**UNITED STATES  
NUCLEAR REGULATORY COMMISSION**  
WASHINGTON, D.C. 20555-0001

**SUBJECT:     DIABLO CANYON POWER PLANT UNIT NOS. 1 AND 2 – FLOOD HAZARD  
                  MITIGATION STRATEGIES ASSESSMENT (CAC NOS. MF7919 AND MF7920;  
                  EPID L-2016-JLD-0007)**

STAFF ASSESSMENT RELATED TO THE  
MITIGATION STRATEGIES FOR  
DIABLO CANYON POWER PLANT UNIT NOS. 1 AND 2  
AS A RESULT OF THE REEVALUATED FLOODING HAZARDS REPORT  
NEAR-TERM TASK FORCE RECOMMENDATION 2.1- FLOODING  
CAC NOS. MF7919 AND MF7920

**Figure 3.2-6a. Door and other opening locations shown in relation to safety and non-safety-related structures at the Diablo Canyon nuclear power plant site at the 140-ft. sundeck elevation. Source: PG&E (2017a)**

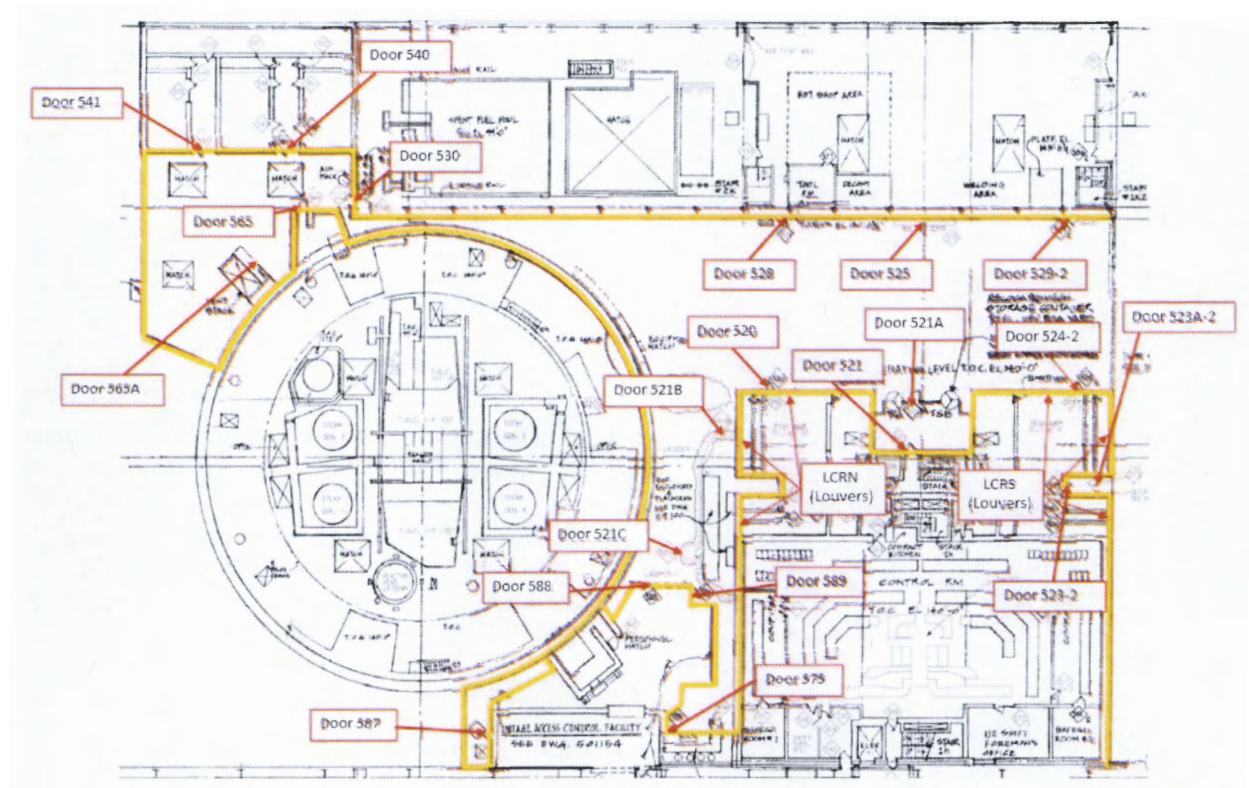
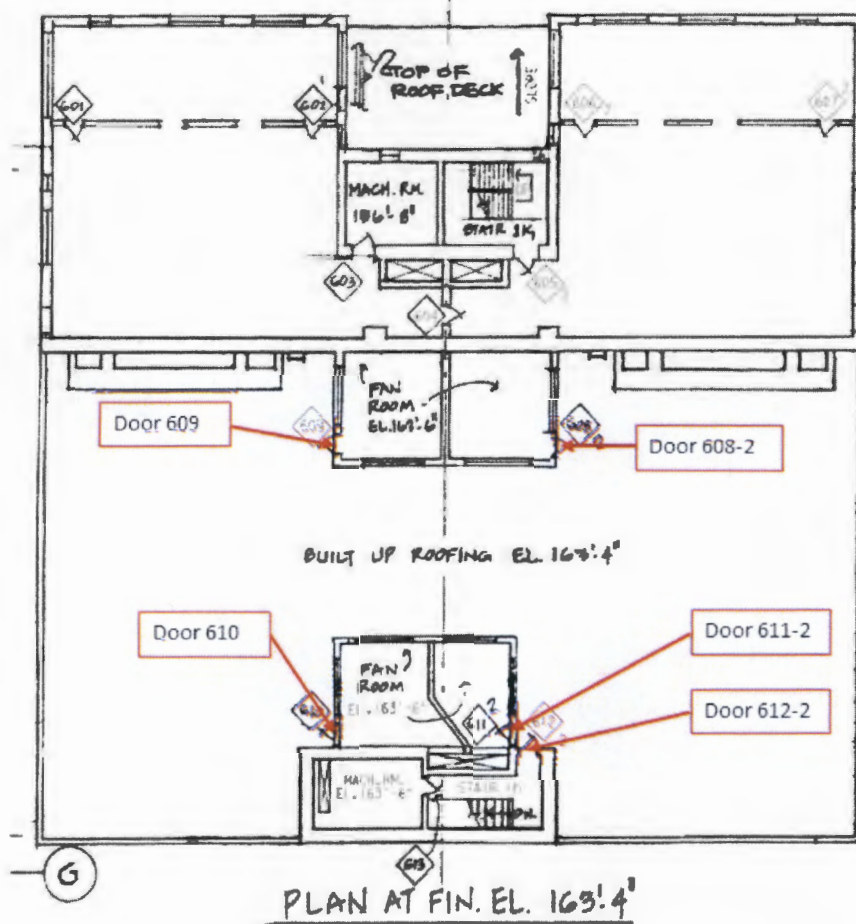
The licensee identified multiple potential locations around each of the two reactor units and other structures by which flood water could potentially pond near the structures in question. In Table 1 of the MSA (PG&E, 2017b), the licensee identified POIs for which LIP-related flood waters exceed the threshold elevation of some of the door openings. Those POIs include both safety-related and non-safety-related buildings and structures. Key monitoring locations around the two reactor units and turbine building identified by the licensee are shown in Figures 3.2-5a and 3.2-5b. In its refined LIP analysis, the licensee identified a total of 61 POIs potentially susceptible to water ingress; 21 more than reported in the revised FHRR (PG&E, 2016a). Those additional POIs occur along what the licensee referred to as the "[elevation] 140-ft sundeck." See Figures 3.2-6a–c.
